APPLICATION NO.	FILING DATE	FIRST NAMED INVENTOR	ATTORNEY DOCKET NO.	CONFIRMATION NO.
10/761,379	01/22/2004	Hisatoshi Yamauchi	032181	2423
38834 7590 07/12/2007 WESTERMAN, HATTORI, DANIELS & ADRIAN, LLP 1250 CONNECTICUT AVENUE, NW			EXAMINER	
			BRADEN, SHAWN M	
	SUITE 700 WASHINGTON, DC 20036			PAPER NUMBER
W1511111010			3781	
	•			
			MAIL DATE	DELIVERY MODE
		•	07/12/2007	PAPER

Application No.	Applicant(s)			
	10/761,379	YAMAUCHI, HISATOSHI			
Office Action Summary	Examiner	Art Unit			
	Shawn M. Braden	3781			
The MAILING DATE of this communication appears on the cover sheet with the correspondence address Period for Reply					
A SHORTENED STATUTORY PERIOD FOR REPLY IS SET TO EXPIRE 3 MONTH(S) OR THIRTY (30) DAYS, WHICHEVER IS LONGER, FROM THE MAILING DATE OF THIS COMMUNICATION. - Extensions of time may be available under the provisions of 37 CFR 1.136(a). In no event, however, may a reply be timely filed after SIX (6) MONTHS from the mailing date of this communication. - If NO period for reply is specified above, the maximum statutory period will apply and will expire SIX (6) MONTHS from the mailing date of this communication. - Failure to reply within the set or extended peri

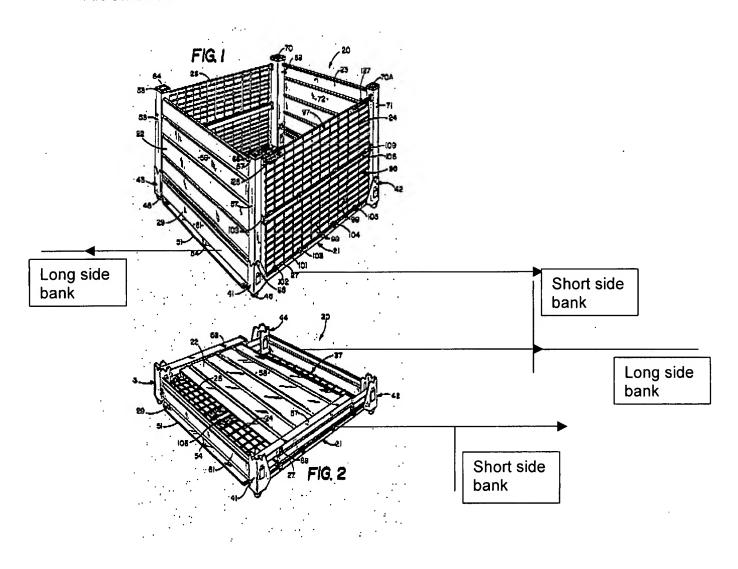
With respect to claim 1, Anderson shows a long-side (61) higher than a short-side bank (27), a bottom fitting portion (51,52), and protruding portions (41,42,43,44), and fitting concave portions (64,67,70,70a).

- 6. Applicant argues that Anderson does not disclose a structure wherein long-side bank portion of the bottom of a large folding container are configured to be higher that short-side bank portion of the bottom. Examiner above has drawn lead lines to figures 1&2 of Anderson more clearly point to the short side and the long side. It can be clearly seen that the long-side bank portion of the bottom of a large folding container are configured to be higher that short-side bank portion of the bottom.
- 7. In response to applicant's next argument that Anderson does not disclose "concave portions" the examiner views "concave" in this case as hollowed inwardly, and Anderson's concave portions (64,67,70,70a) certainly meets that interpretation.
